BLM SCALAR FIX -Based on findbhudda's original design:
<http://www.midibox.org/dokuwiki/doku.php?id=findbuddha>

DESIGN FILES:

Corrected blm-scalar v1.1.brd below & attached: [blm-scalar_v1.1.zip](#)

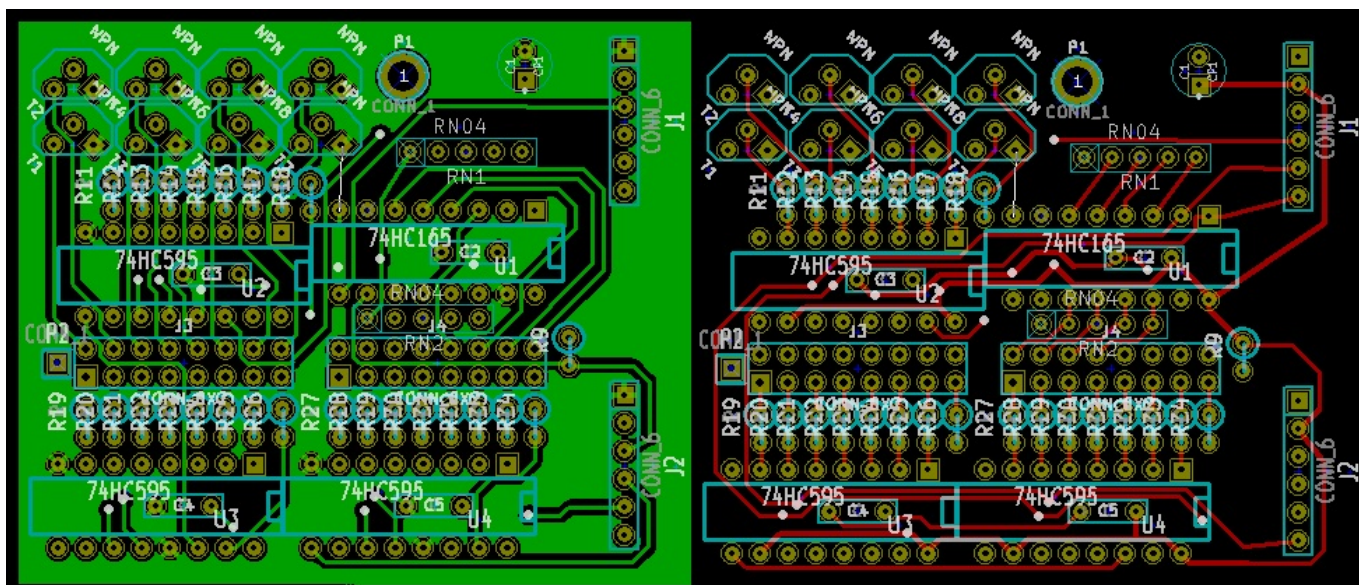
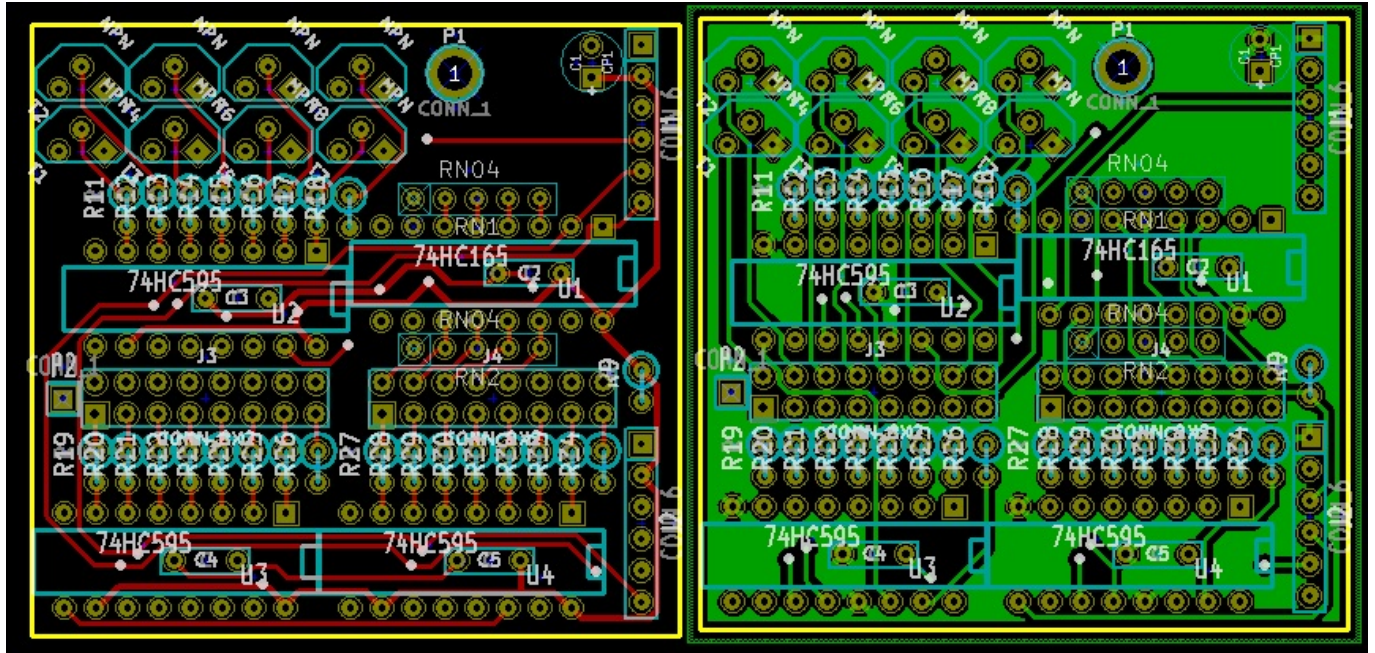
- blm-scalar.* contain an error. Pins I4-I7 are mirrored. This is easily fixed with a connector modification, and the blm-scalar module seems to work as intended.
- blm-scalar v1.1 attempts to fix this error. Moved connectors J1, J2 & Resistor Net 1 to make room for corrections.
